SITING AND GRADING PLAN

Royal Pine Homes / Centerfield Properties Inc - 216102
"OAKRIDGE MEADOWS", RICHMOND HILL, ON

Block / Page Number
BLOCK 60

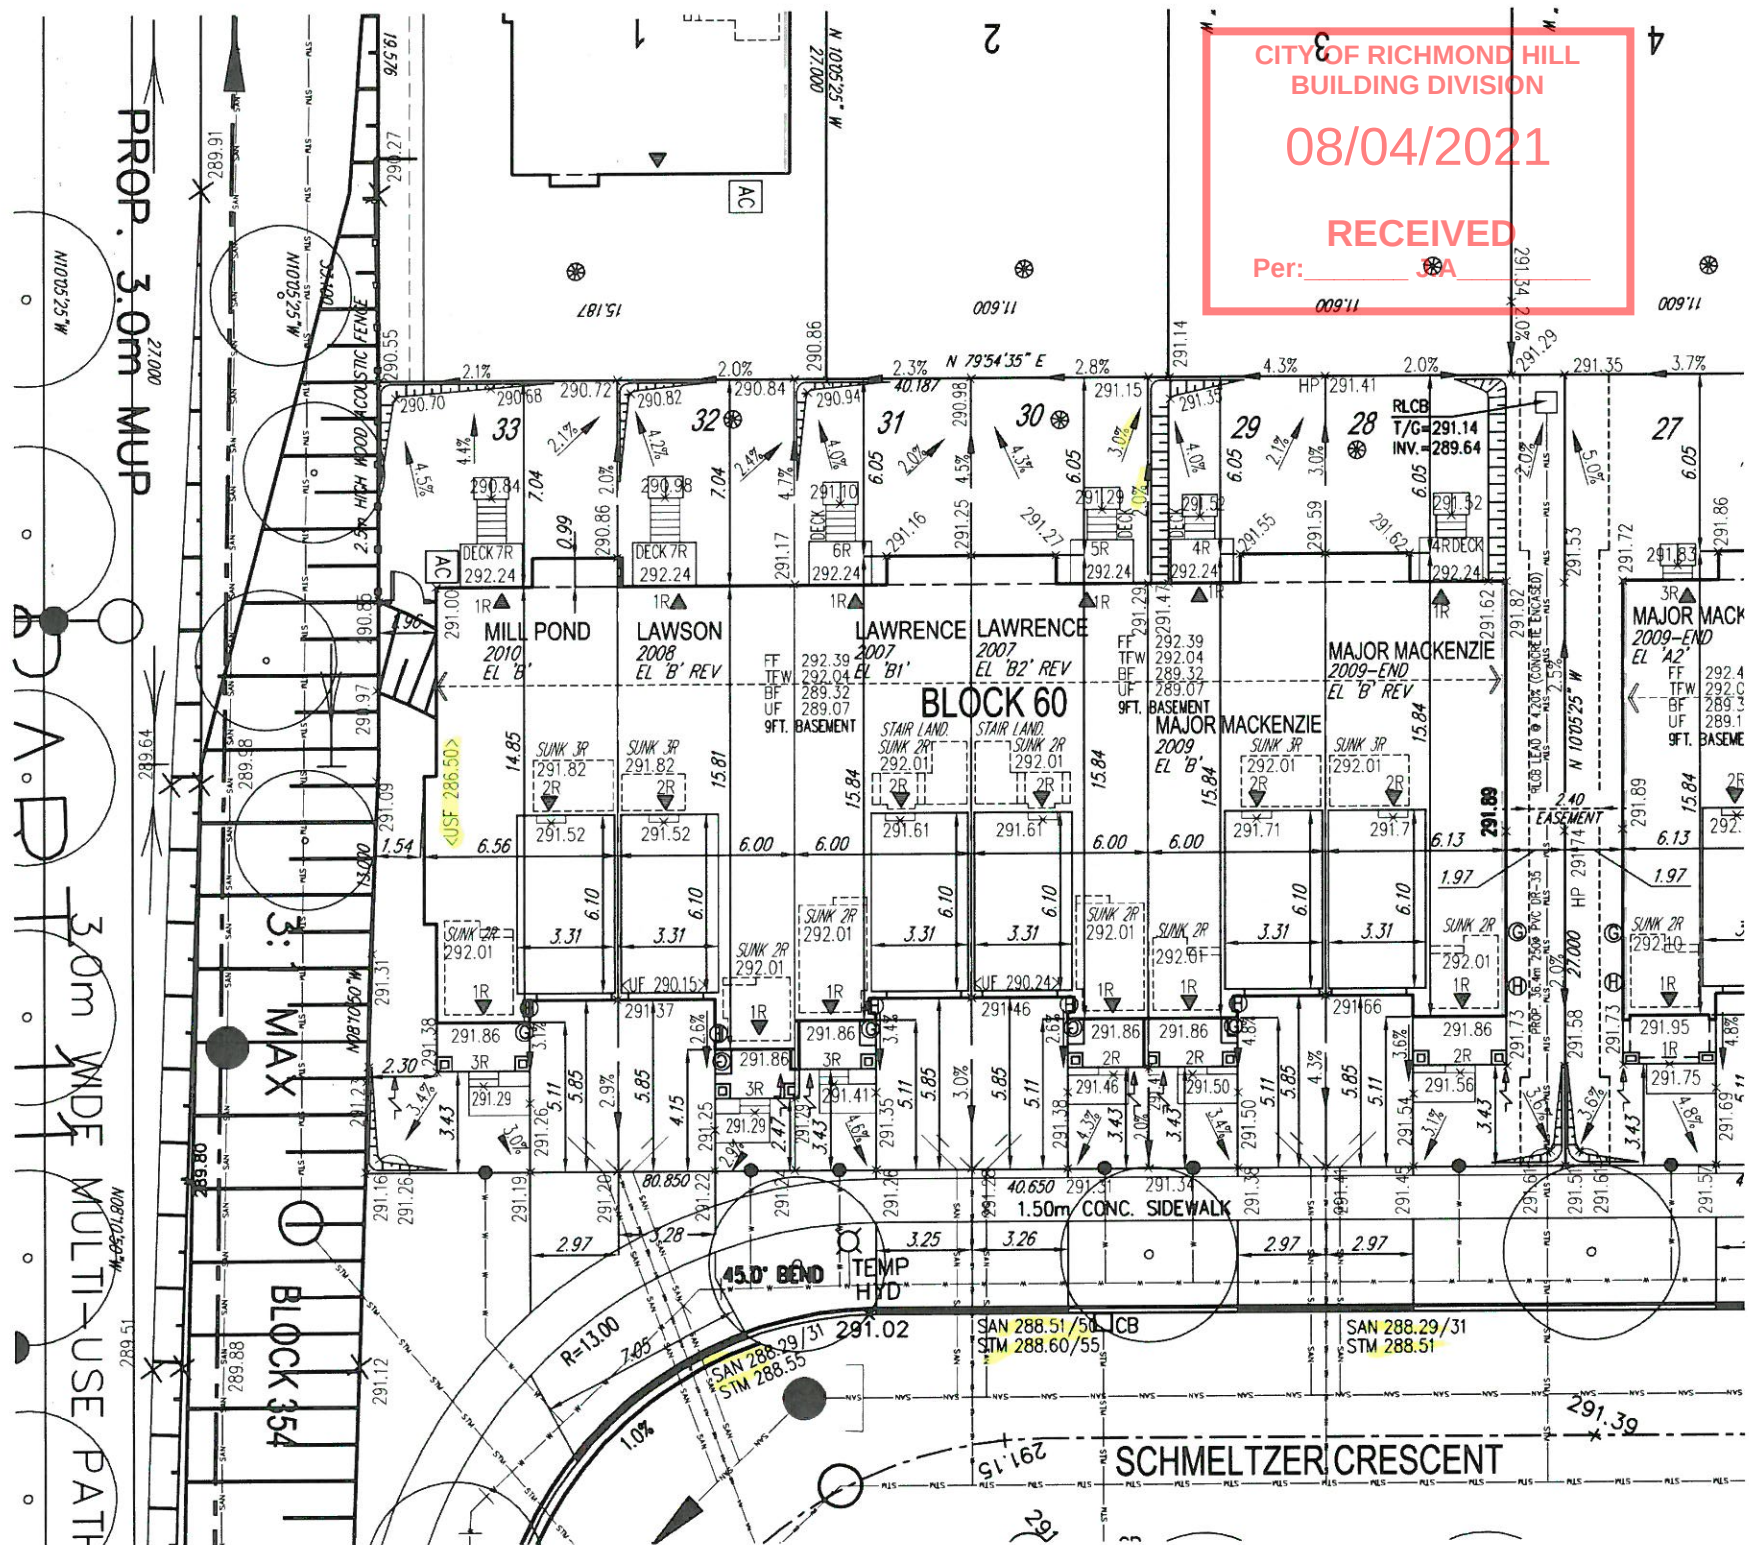
No unprotected openings permitted within 1.2 meters of the lot line as per article 9.10.14 of the Ontario Building Code.

As per OBC 2012, Div.B, 9.10.14.5(5), projections such as balconies, eaves, stairs, etc., that are more than 1m above grade, shall be non-combustible when within 1.2m of a property line or 2.4m of a combustible projection on another building on the same property.
